883 Congress St.

Garage, Office, overpass

Re: MAINE MEDICAL CENTER REVISED PLANS

**RE: Maine Medical Center Office Building**

Level 2

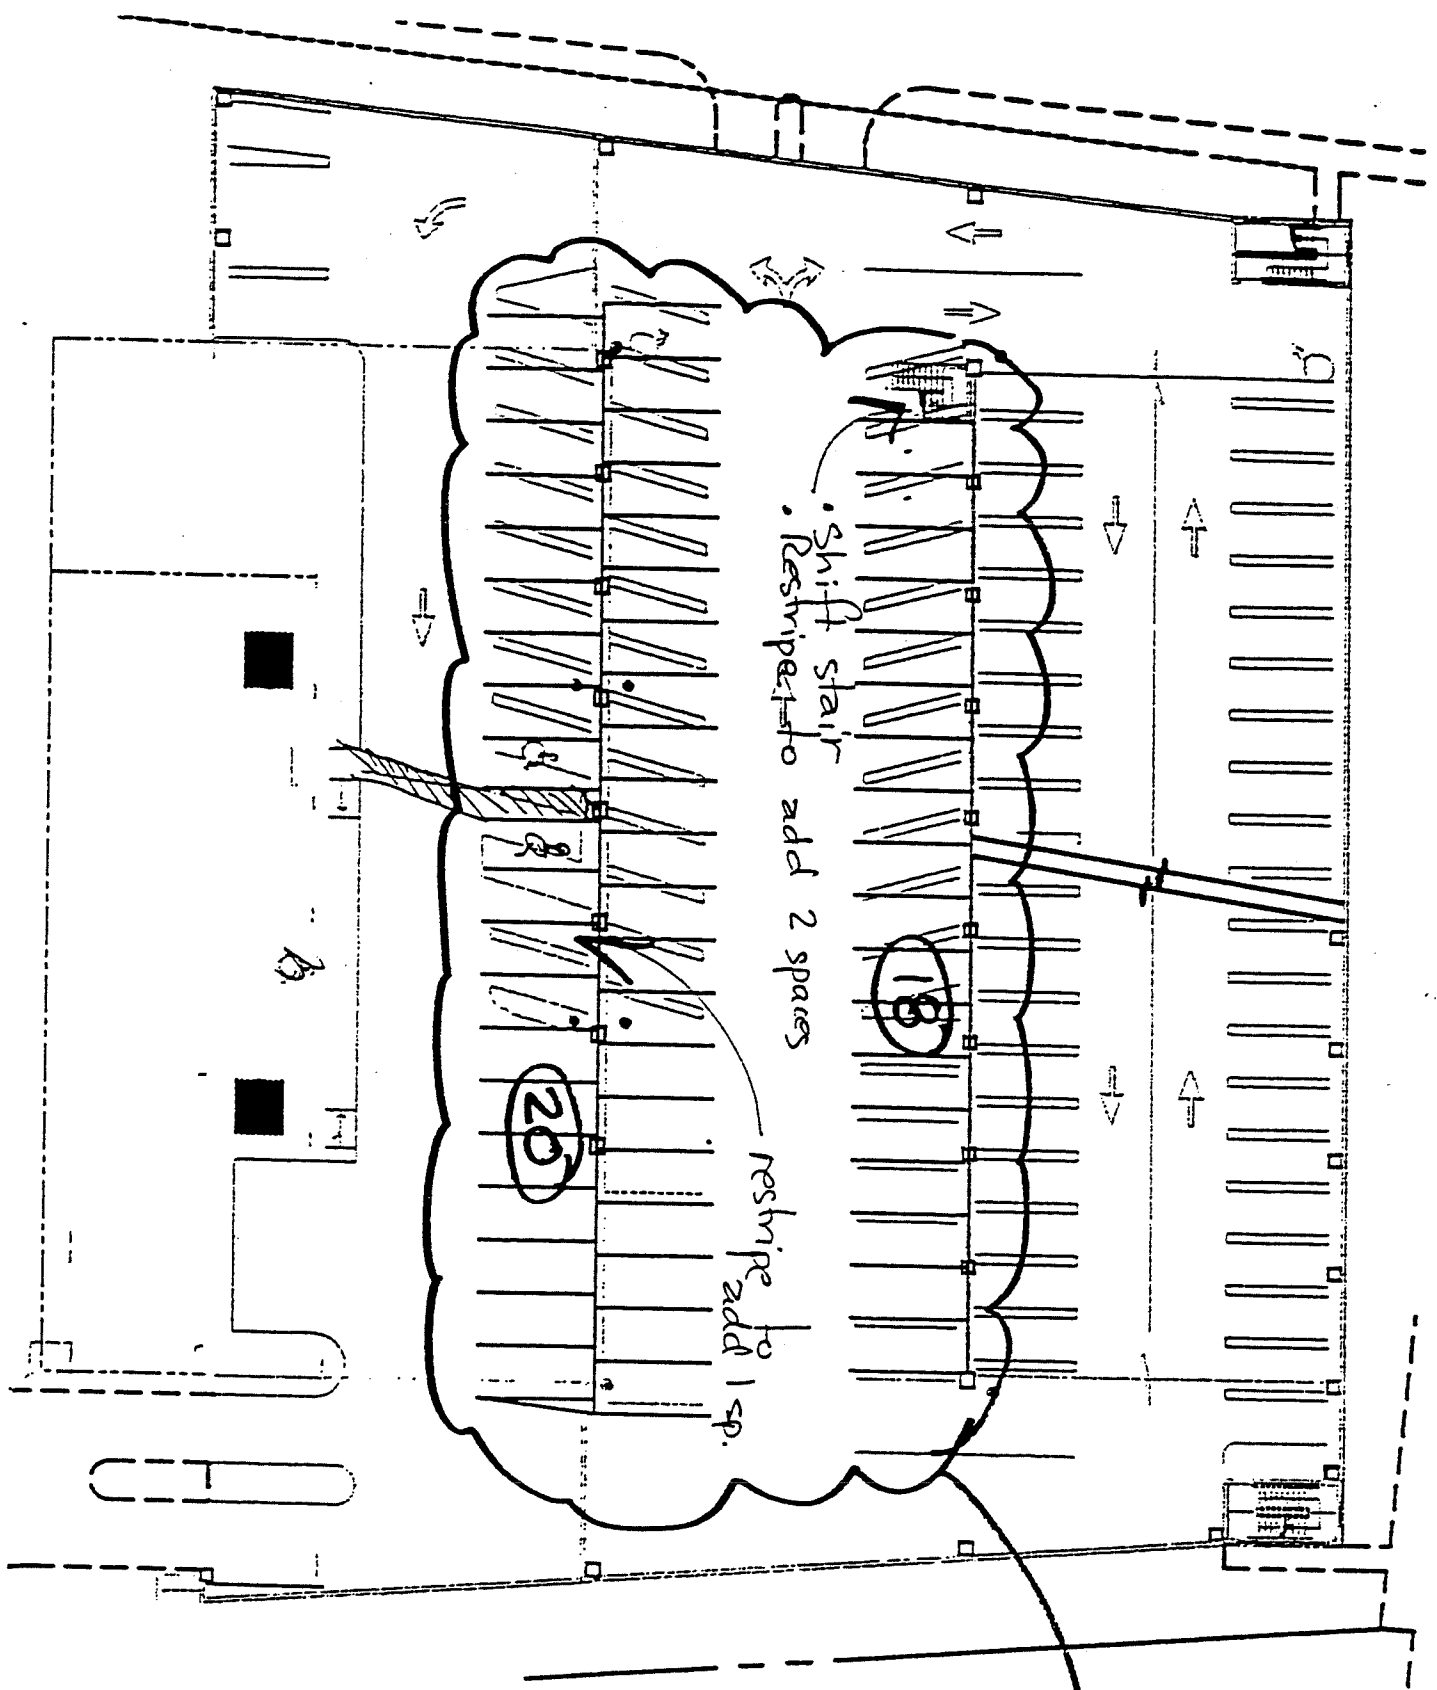
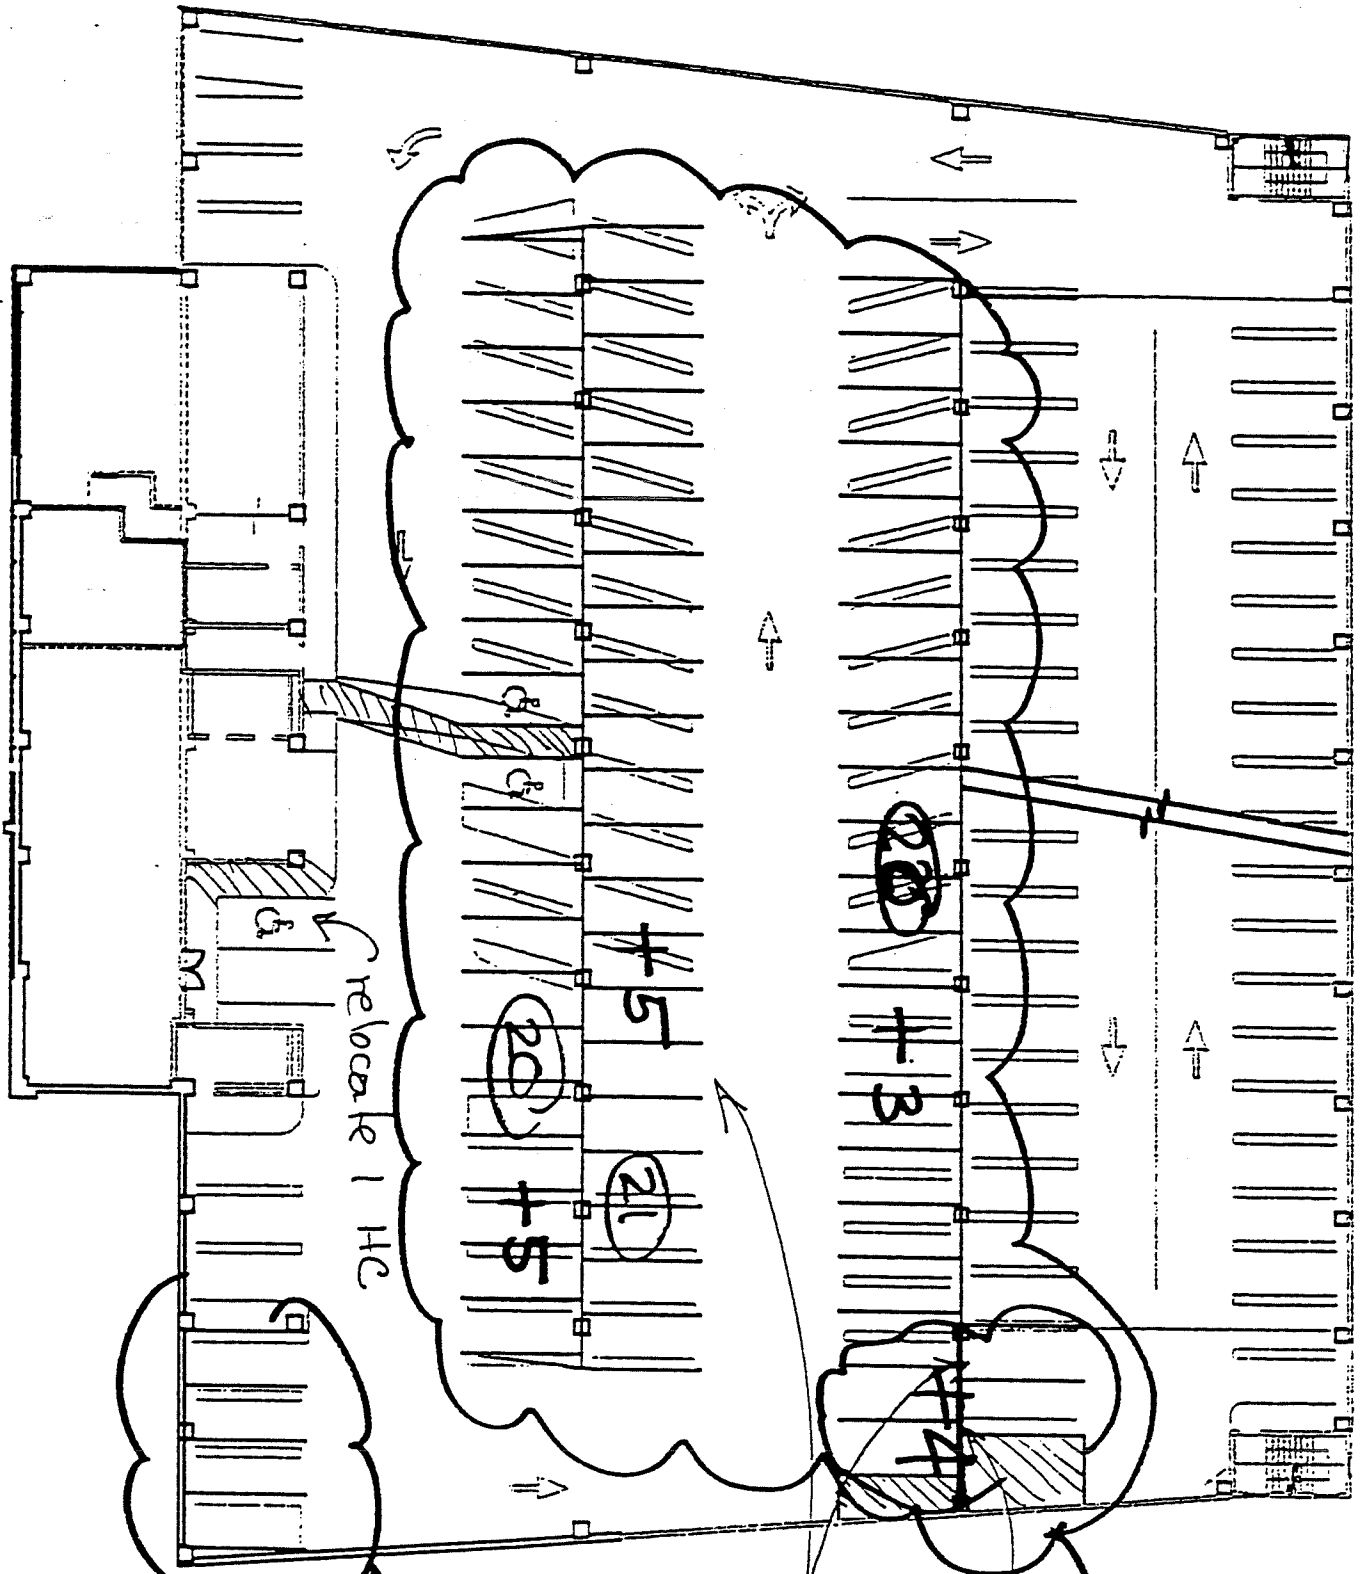
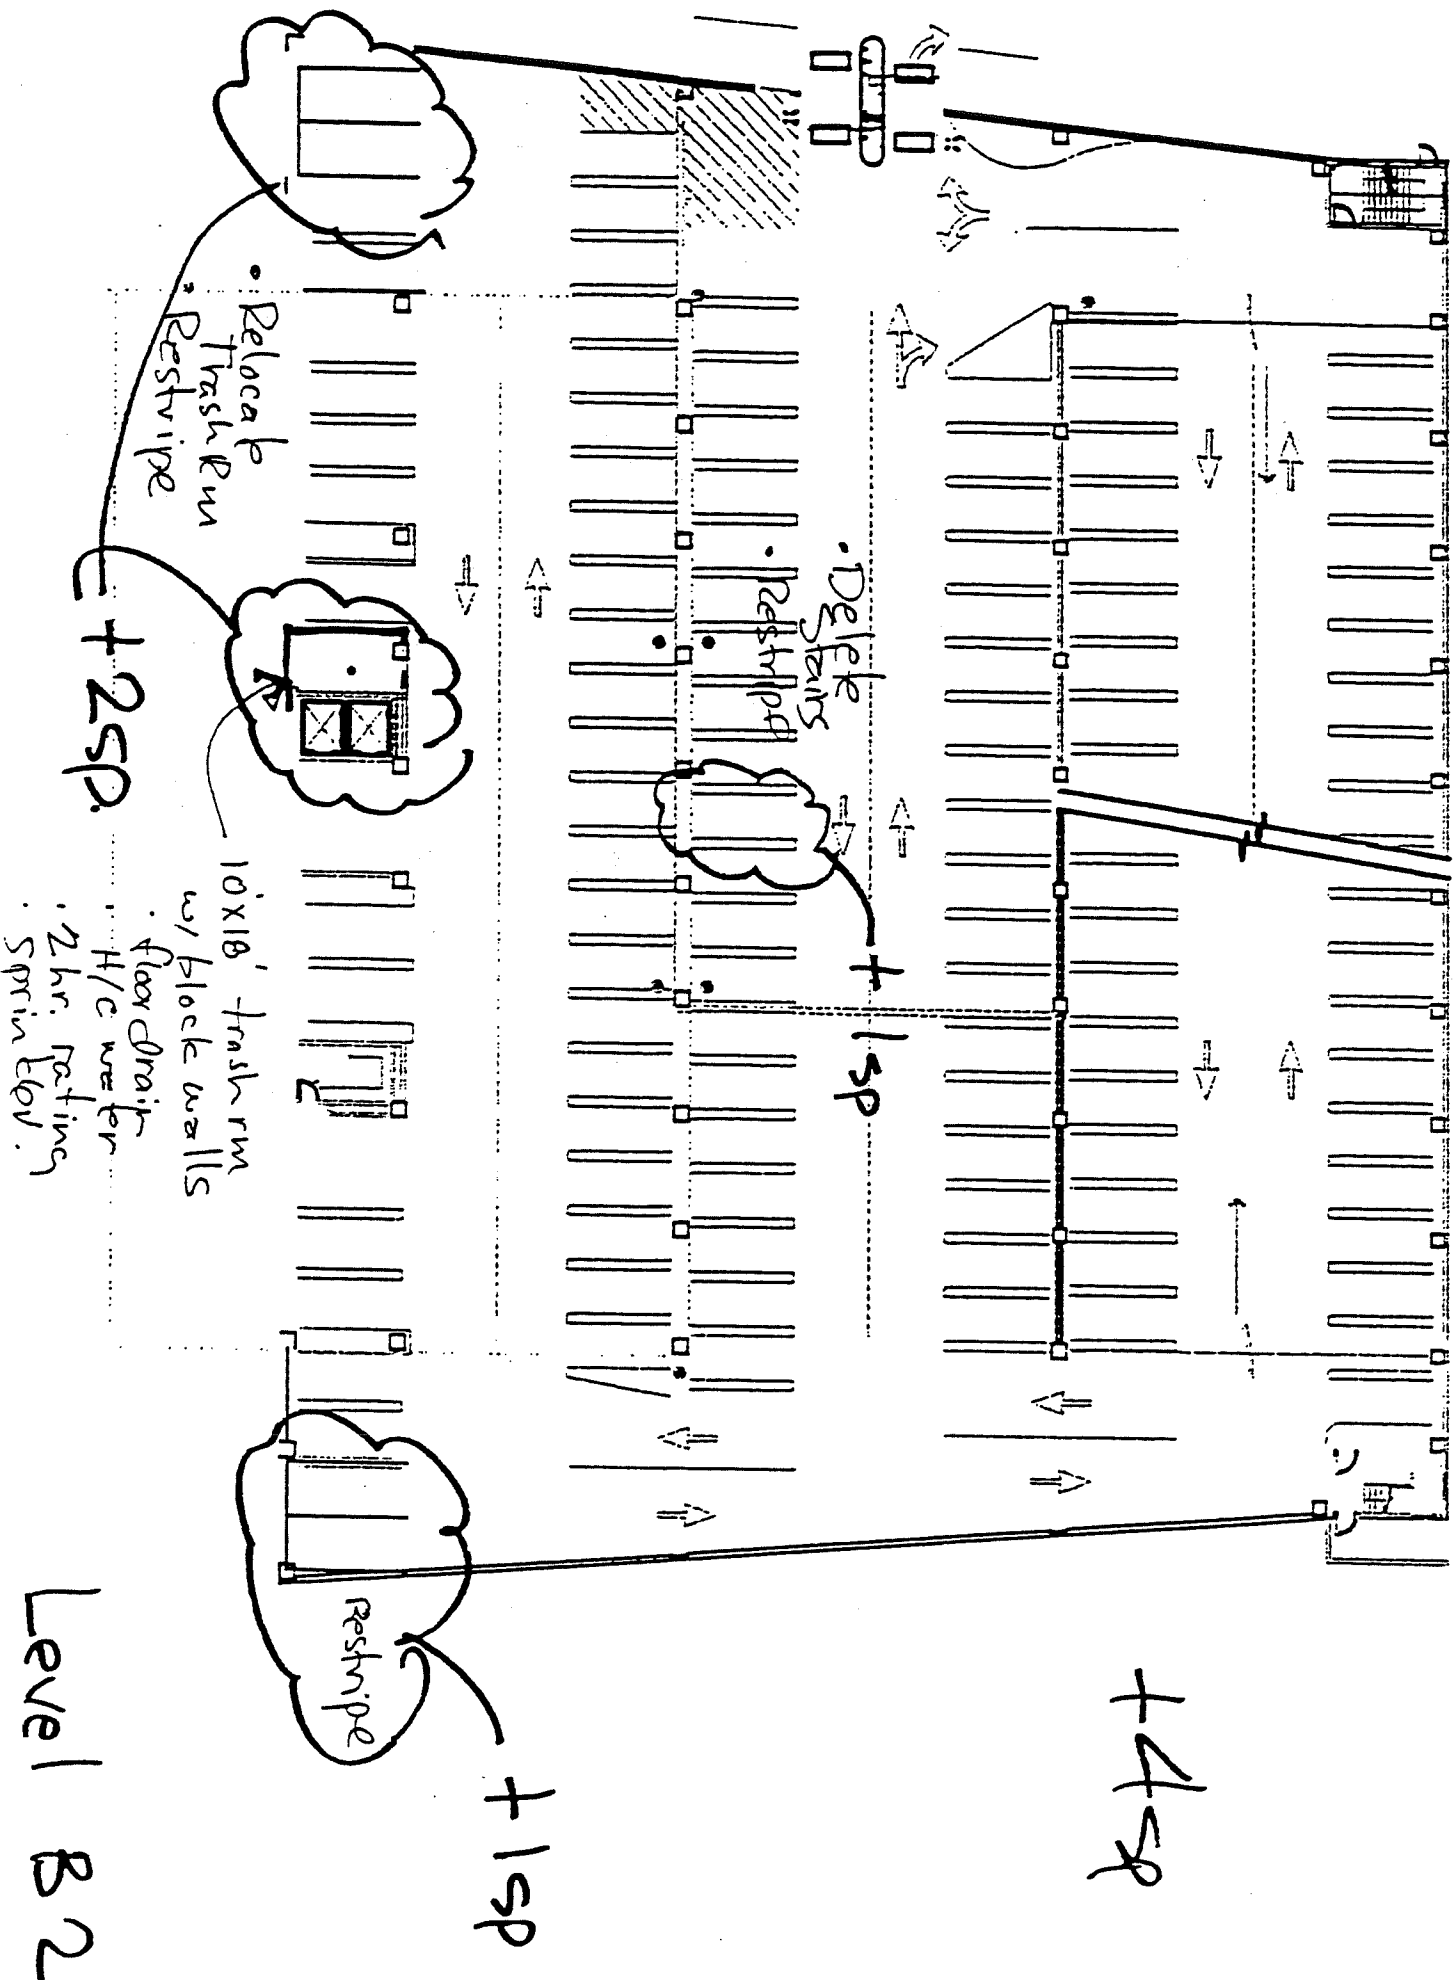
Staff has reviewed the submitted drawings including the overlay plan. We do not have any objections to the revised plan; however, before we sign-off on the changes, please submit the following information:

- a. A summary of the number of parking spaces on each level (original plan vs. revised plan) with a grand total showing the same number of spaces.
- b. A letter from Maine Medical Center that the revised plan will not affect their pledge to preserve Sea Dog parking and resident snowday parking.
- c. A definitive statement that the exterior appearance of the parking garage remains the same.

Shift stair  
Reshape to add 2 spaces

Reshape to add 1 sp.

+1 sp  
restripe

Delete Ballards  
and drive  
lane — restrip

17 sp  
new divider.

+2sp restripe
